February 4, 2020

**Re: Response to DEP Comments for HDD Re-Evaluation Report
SPLP HDD No. S3-0300 Park Road Crossing
PADEP Section 105 Permit No.: E15-862
Upper Uwchlan Township, Chester County**

Mr. John F. Hohenstein P.E.
Response to DEP Comments on HDD S3-0300
February 4, 2020

Figure 2. Redesigned 20-Inch HDD Plan and Profile

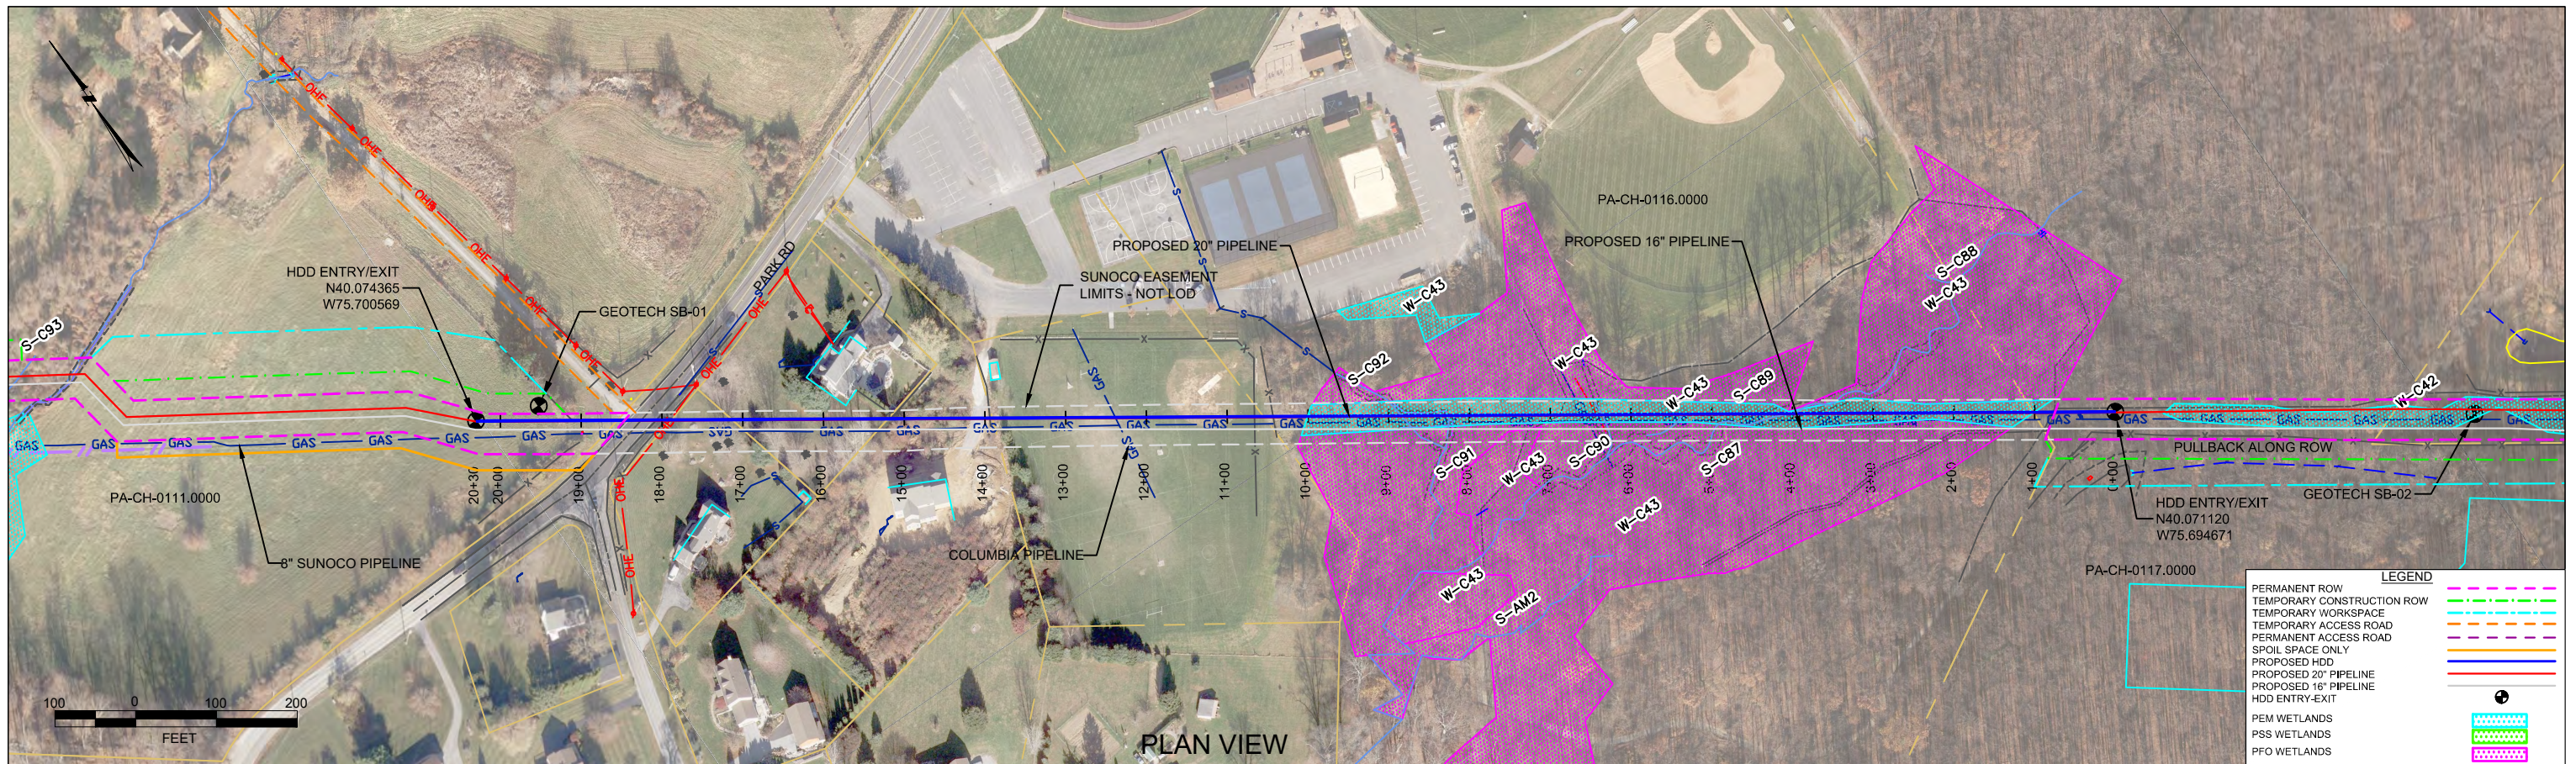
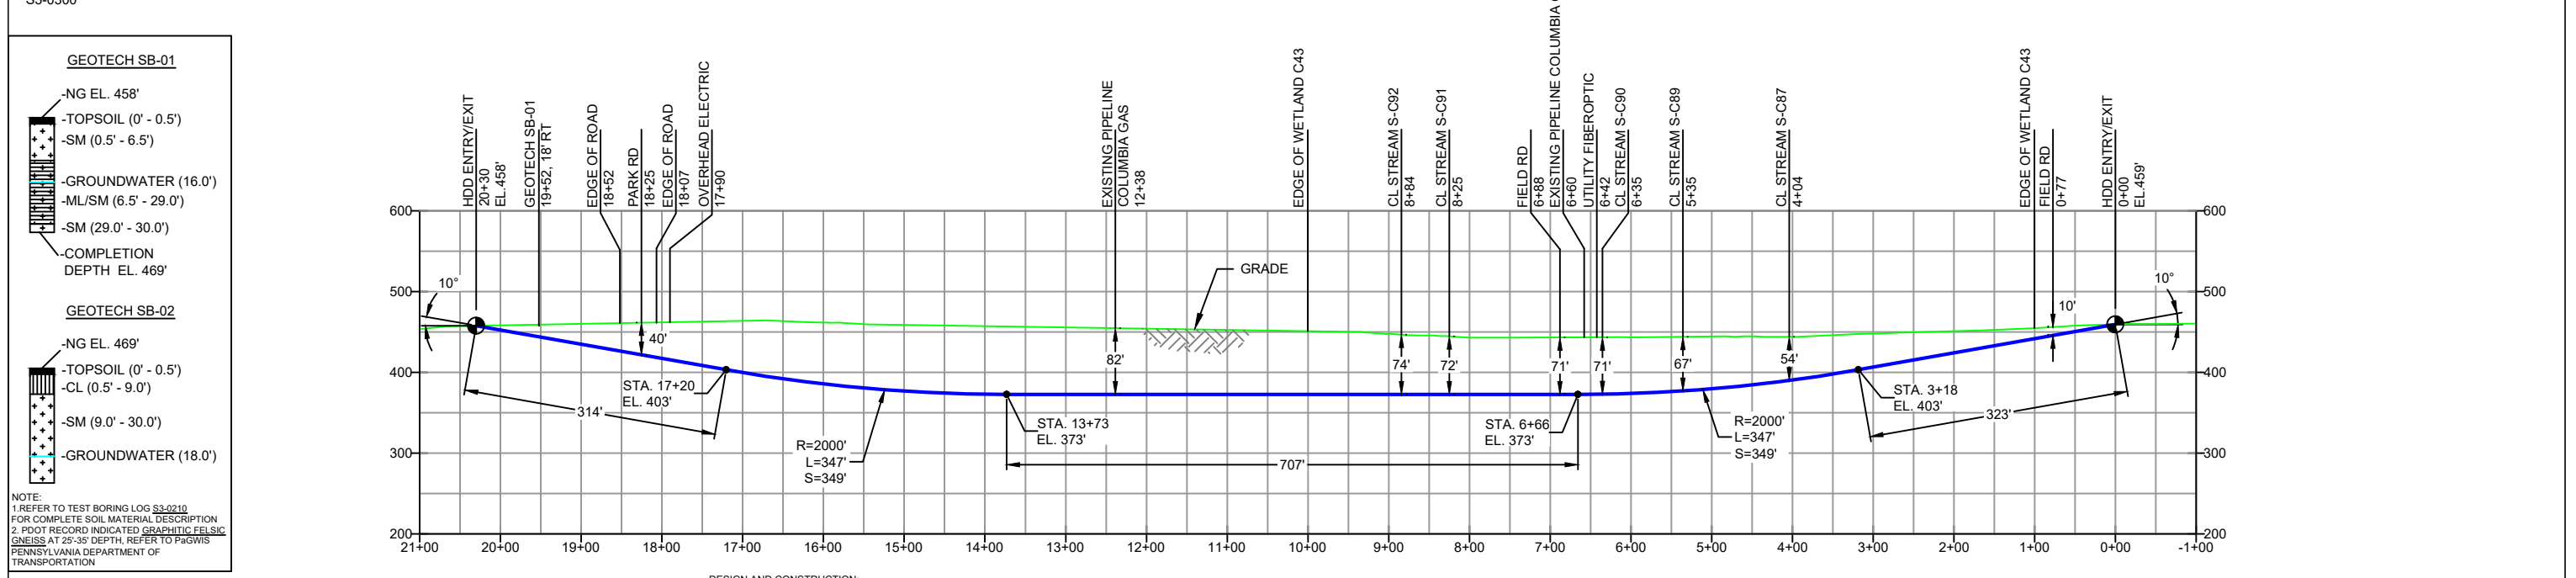
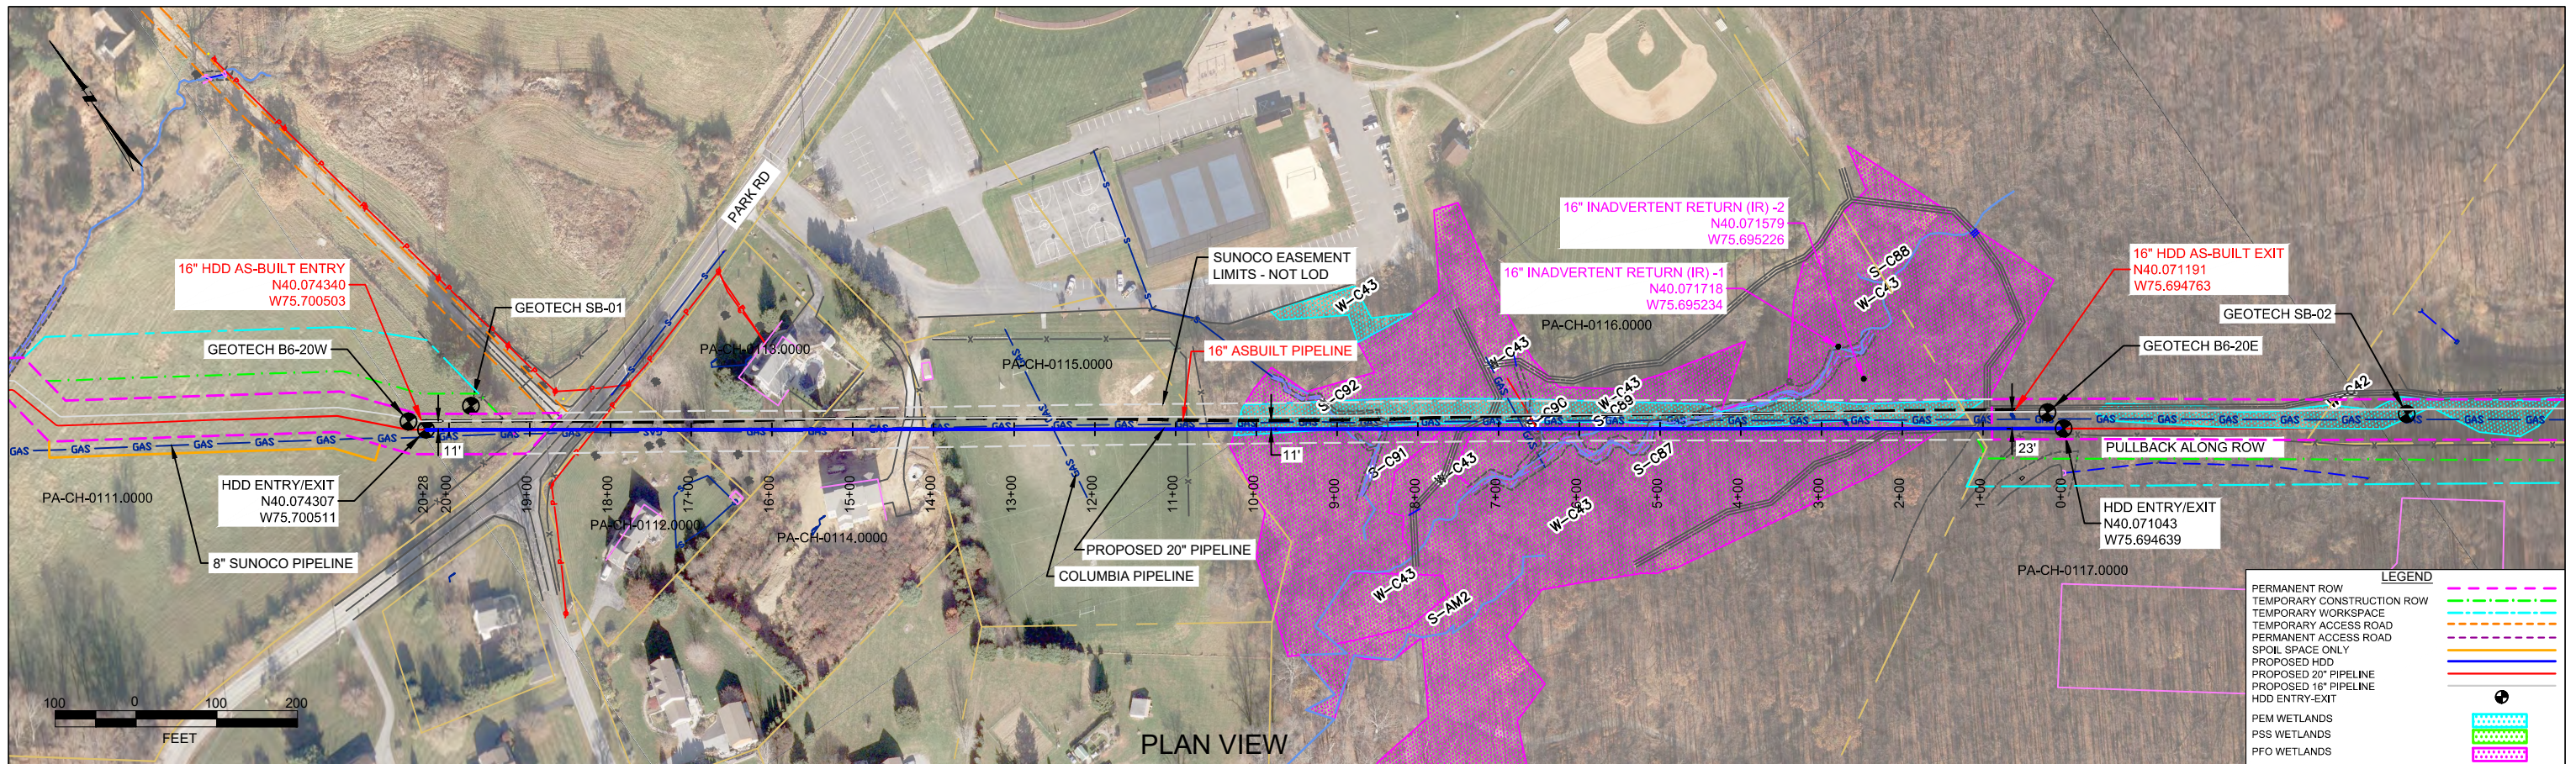
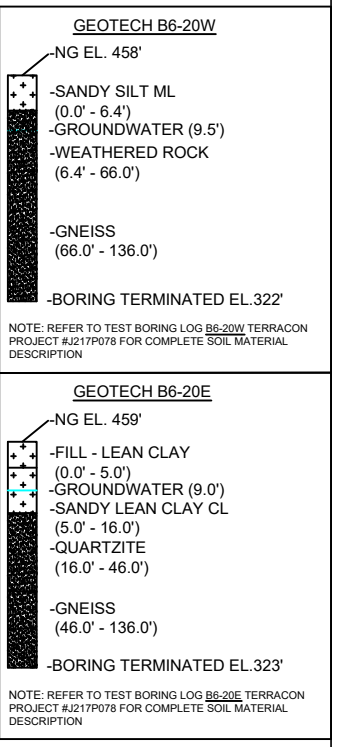
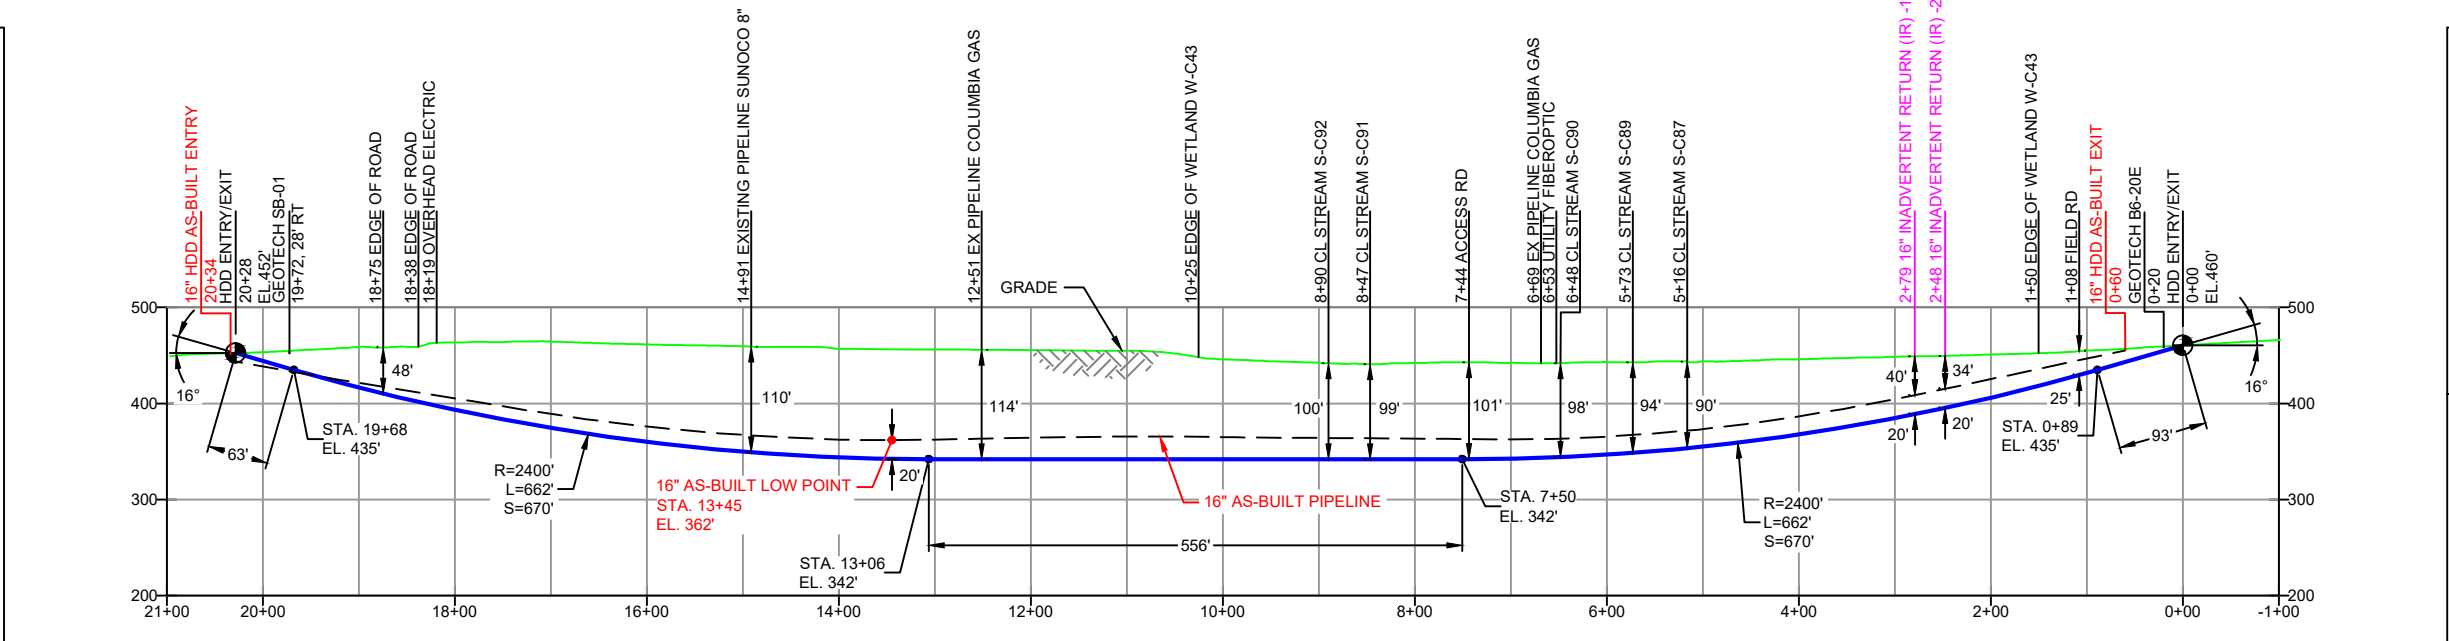
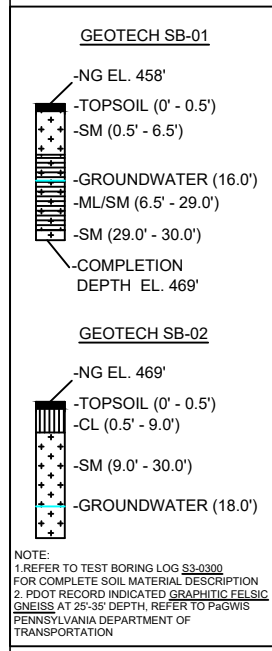
- 1. The proposed maximum depth for the 20-inch pipeline is 114 feet below ground surface (bgs), which is 27 feet deeper than the original permitted alignment. This maximum depth corresponds to an elevation of 342 feet above mean sea level (MSL). According to the boring logs and photographs of the drill core provided, the bedrock at this elevation in boring B6-20W is highly weathered and has a low rock quality designation (RQD) of 27 percent. A highly fractured zone is present at this same elevation in boring B6-20E at the northeast entry/exit point, from elevation 342.2 to 340.9 feet MSL. No deep borings between the entry/exit points that evaluate bedrock conditions at the deepest point of the pipeline bore to determine if these highly weathered/fractured zones extend beneath the alignment and for what distance. These highly weathered/highly fractured zones may be more susceptible to a loss of drilling fluids and may increase the likelihood of an inadvertent return (IR).**

- 2. A review of the geophysical profiles for the proposed HDD alignment indicates that neither the seismic nor the electrical resistivity profiles penetrated the subsurface down to the lowest elevation of the proposed 20-inch pilot bore, at 342 feet MSL, for the entire distance between the entry/exit points. As such, it cannot be determined whether the highly weathered/fracture zone described above is present beneath the alignment due to the lack of data. SPLP needs to provide technical justification and supporting data for the proposed depth of the pilot bore.**

SPLP drilling specialists revised this HDD design which increased the profile depth by 32 ft below the permitted profile depth, and increased the entry/exit angles to near maximum rig elevation levels, while accounting for stress during the pipe pull from east to west. SPLP acknowledges the Departments concern with the qualities of the bedrock at profile depth; however, the quality of the rock at the actual drilling depth has less meaning to the prevention of IRs than the quality of the bedrock layers above drilling profile. As discussed below, it is the overlying geologic materials which contain and control the annulus pressures and suppress the vertical movement of drilling fluids.

SPLP has considered all geologic data and the events during installation of the 16-inch pipeline and has redesigned the 20-inch HDD profile. A summary of the redesign factors is provided below. The original and redesigned HDD plan and profile for the 20-inch pipeline are provided in Attachment 2.
